New LANCER LEV Portion Control replaces the TouchSensor Portion Control2
New LANCER EZ-Fill Valve Update3

Technical Bulletin Distribution:

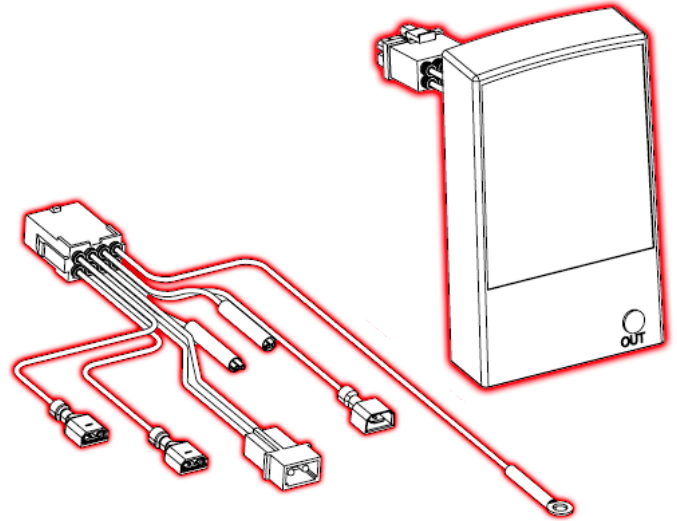
Lancer EZ-Fill valves were having issues with continuity causing the valves to remain in the on position and not shut off once activated.

Originally, a supplier discontinued the production of the conductive plastic resin that the bonnet was made of. We used that conductive resin to provide continuity throughout the flow stream, allowing there to be a complete circuit and triggering shut off when water touched the lever and the valve.

Once that plastic resin was discontinued, Lancer decided to move to a modified harness that will allow the ground to be placed on the facet plate and connect to the flow stream from the back block. This solution later caused issues where sometimes the circuit board would short out. Other times there were issues with having a proper ground and the valves would not shut off.

Lancer has decided to move back to using the bonnet, but instead of sourcing a conductive plastic resin, Lancer decided to use a stainless-steel bonnet. This will provide necessary continuity, remove the risk of shorting the circuit board, and allow for a consistent ground source.
